Industry Comments on Draft NRC Safety Evaluation: NEI 16-03, Revision 1, “Guidance for Monitoring of Fixed Neutron Absorbers in Spent Fuel Pools”

December 14, 2023

Guidance for Monitoring of Fixed Neutron Absorbers in Spent Fuel Pools

NRC Public Meeting

Draft SE: i-LAMP Components

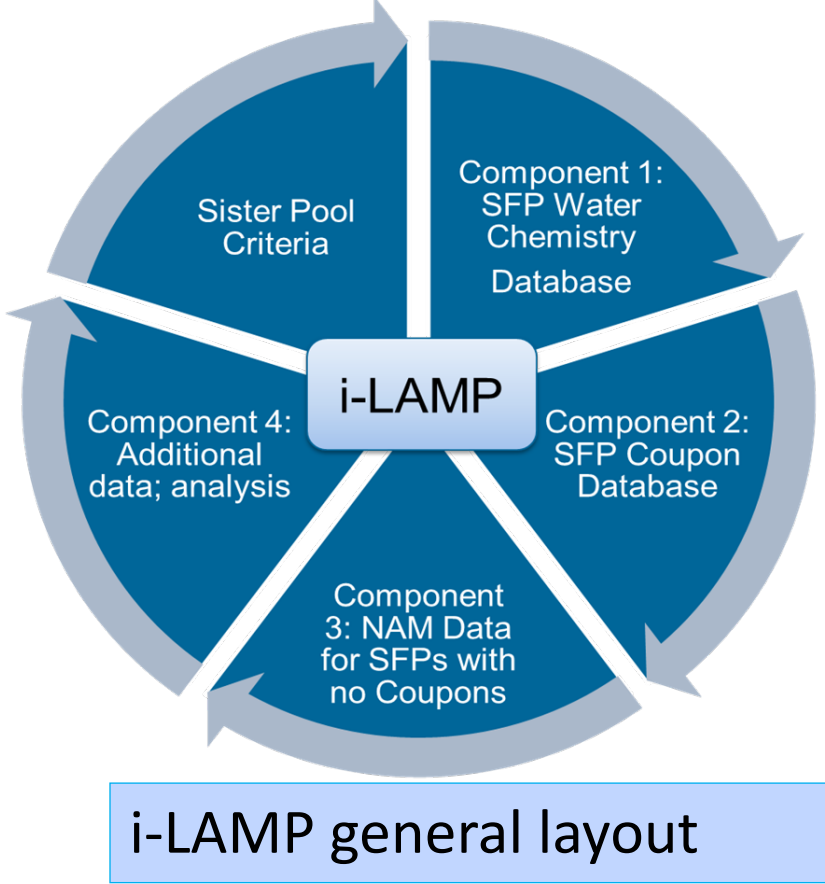
Section 3.3.1, page 7, line 31: “The core of i-LAMP is an SFP coupon database”

i-LAMP not only relies on coupon database but also has other vital components to be considered an effective monitoring program

Draft SE: i-LAMP Components

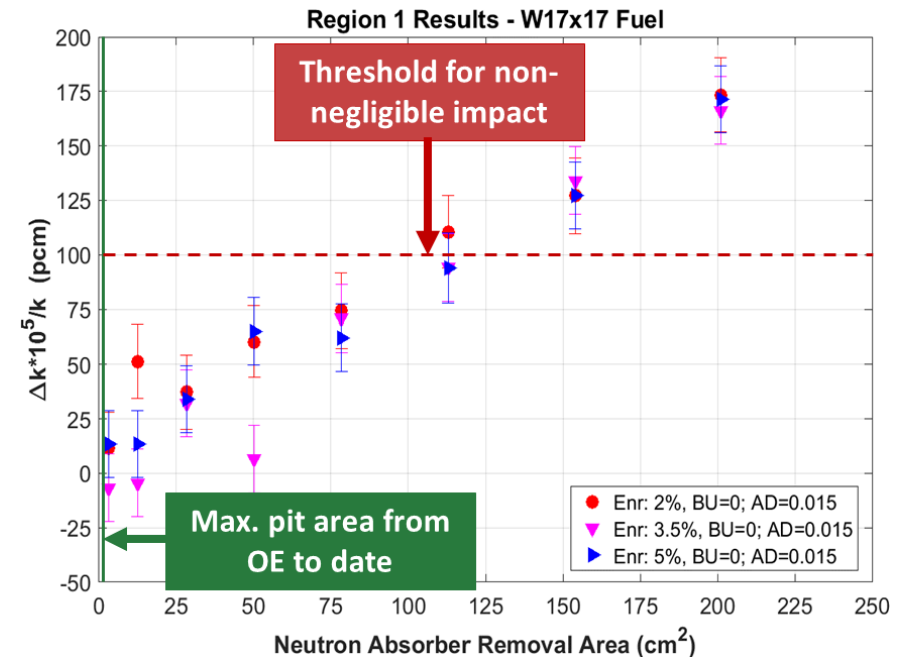
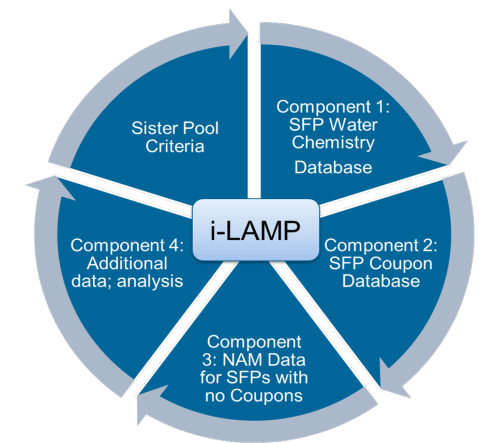
Section 3.3.1, page 7, line 31: “The core of i-LAMP is an SFP coupon database”

Suggested change:

Key components of i-LAMP are SFP coupon database, water chemistry, and analysis. Analysis not only includes data analysis for coupons and water chemistry but also impact on reactivity.

Sister/Sibling pool criteria will depend on the analysis when/if trends are established since i-LAMP is a learning program

How similar is similar enough? Panel Histories: Case-1 (C-1) versus Sibling-1 (S-1)

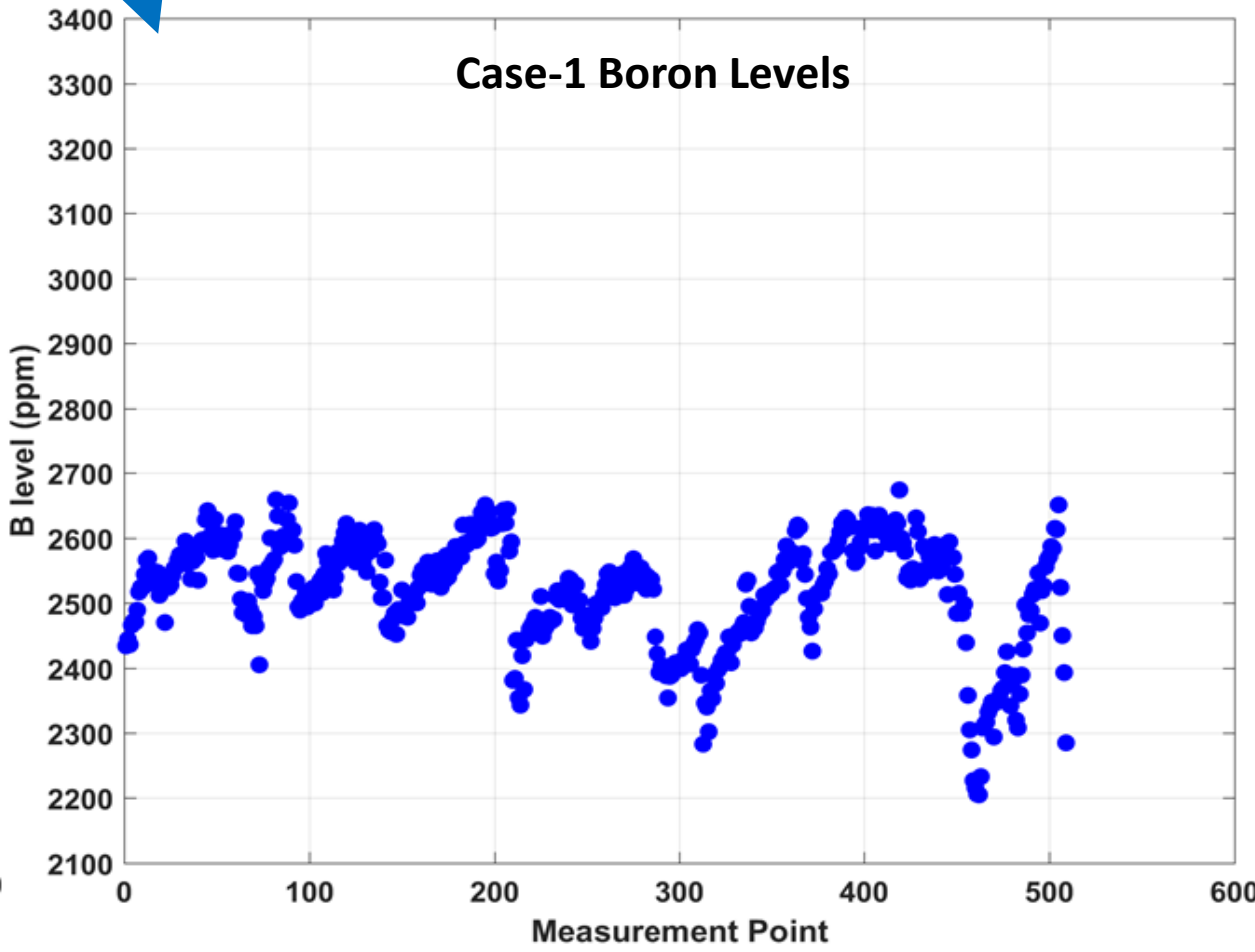
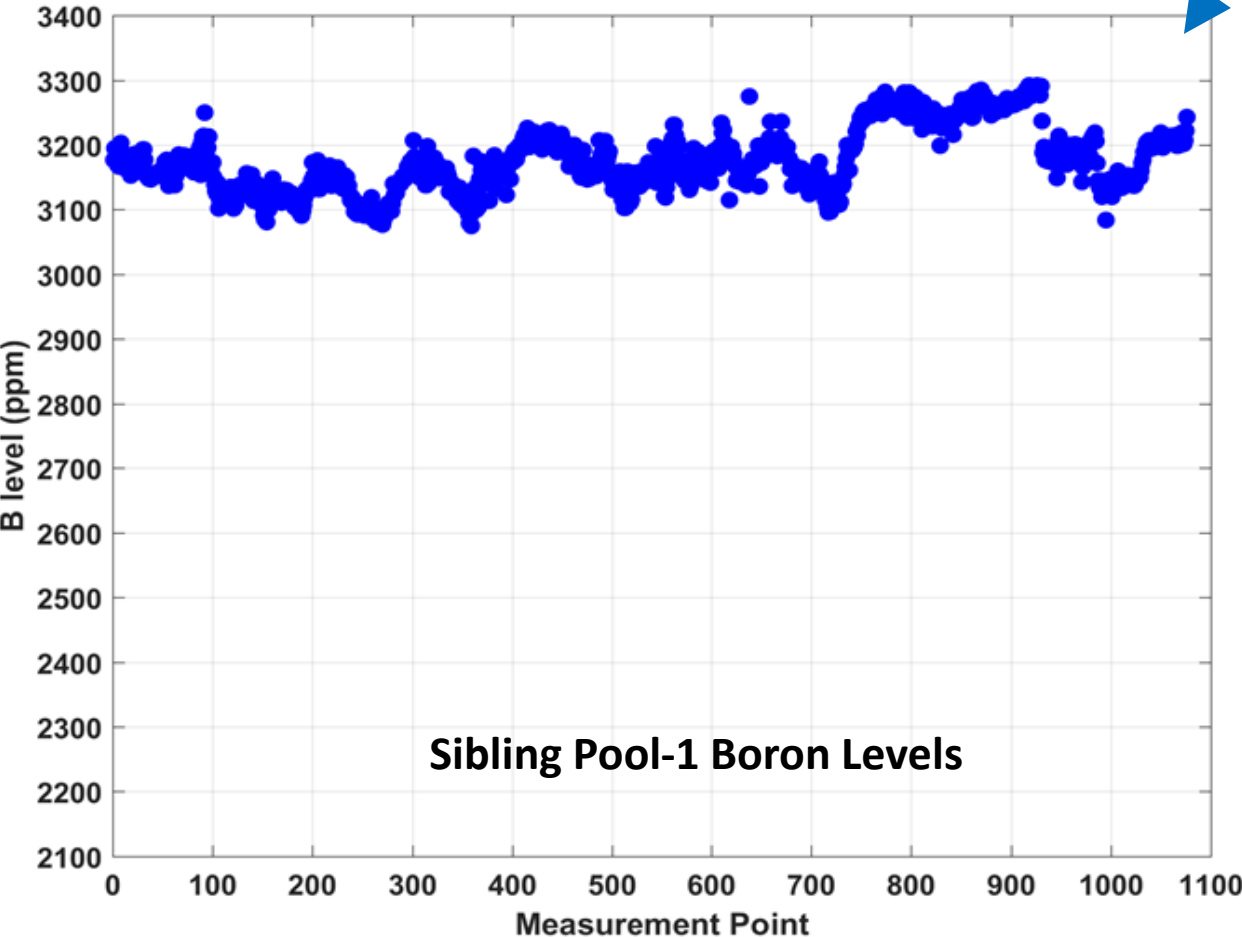
Case 1 has OLDER BORAL but less service time? Can they still use coupons from Sibling 1 based on draft SE language?

How similar is similar enough: Water Chemistry for Sibling Pool-1 versus Case - Boron Levels

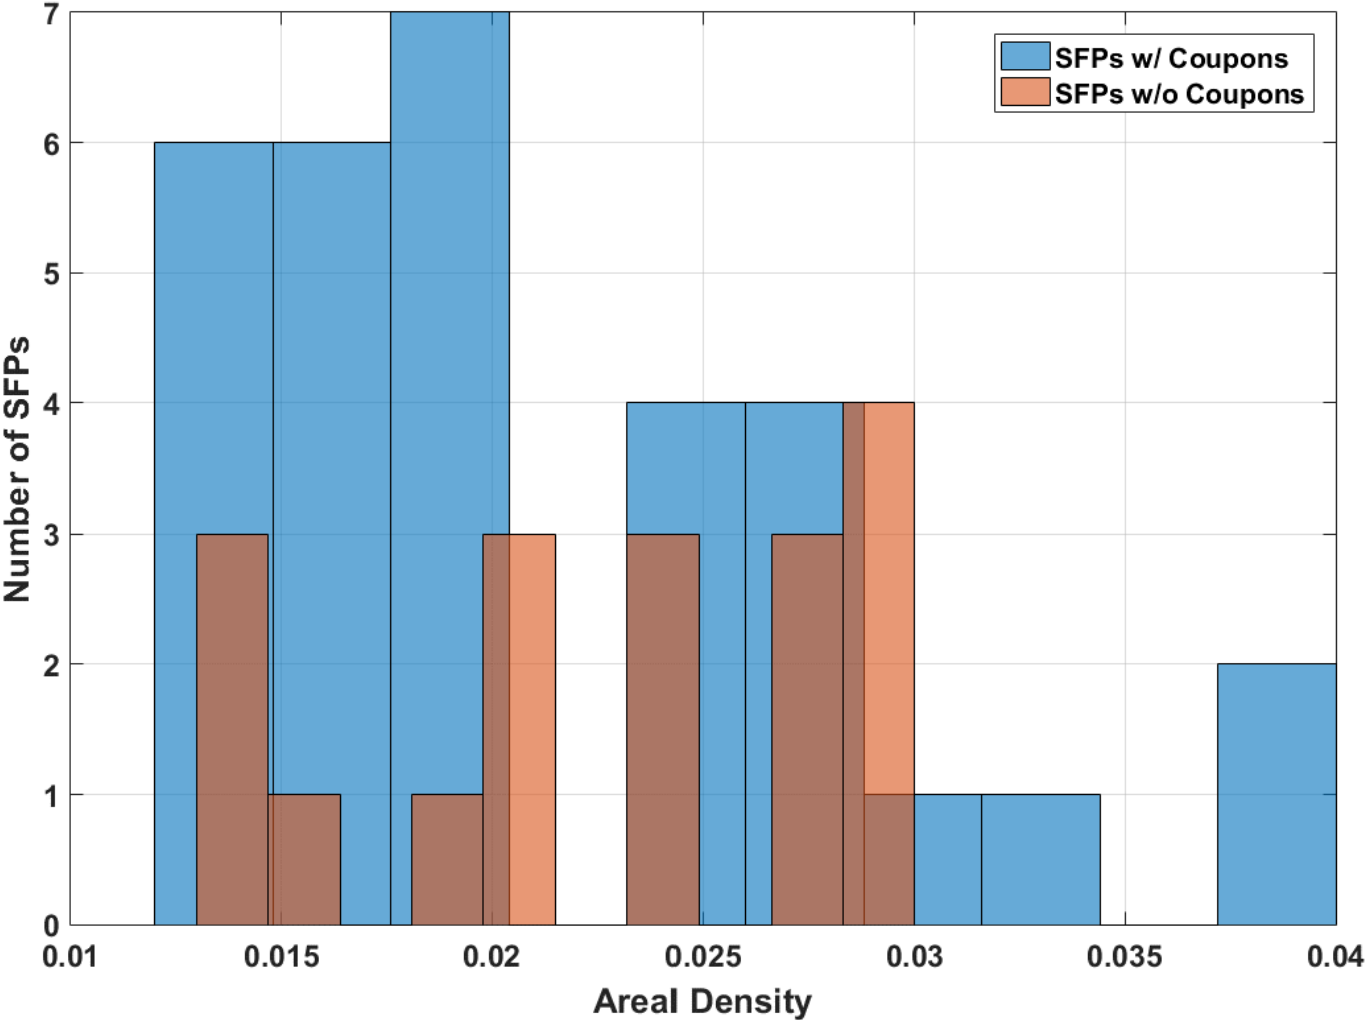
Are these similar enough?

Case-1 Boron levels lower than Sibling Pool-1 Boron levels and more consistent with industry averages – despite differences, can they still use coupons from Sibling-1?

Current Draft SE versus Proposed Change

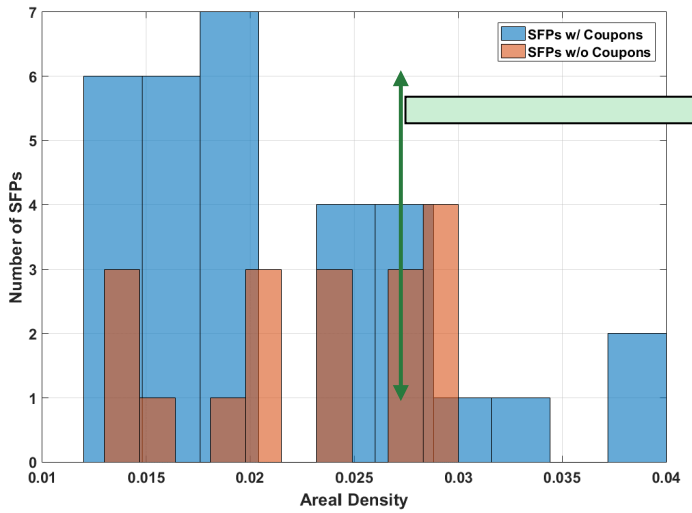
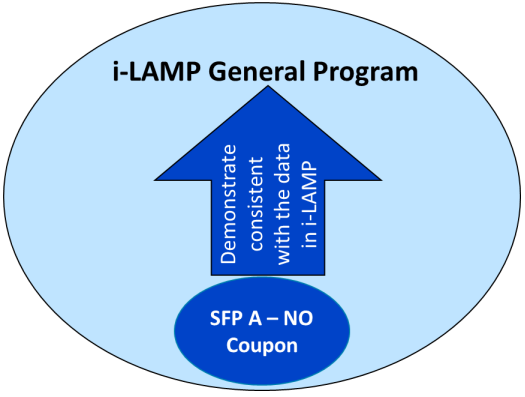
Further binning and sibling determination will be done when/if a trending parameter(s) is established. Proposed approach maintains “industrywide” and “learning” components
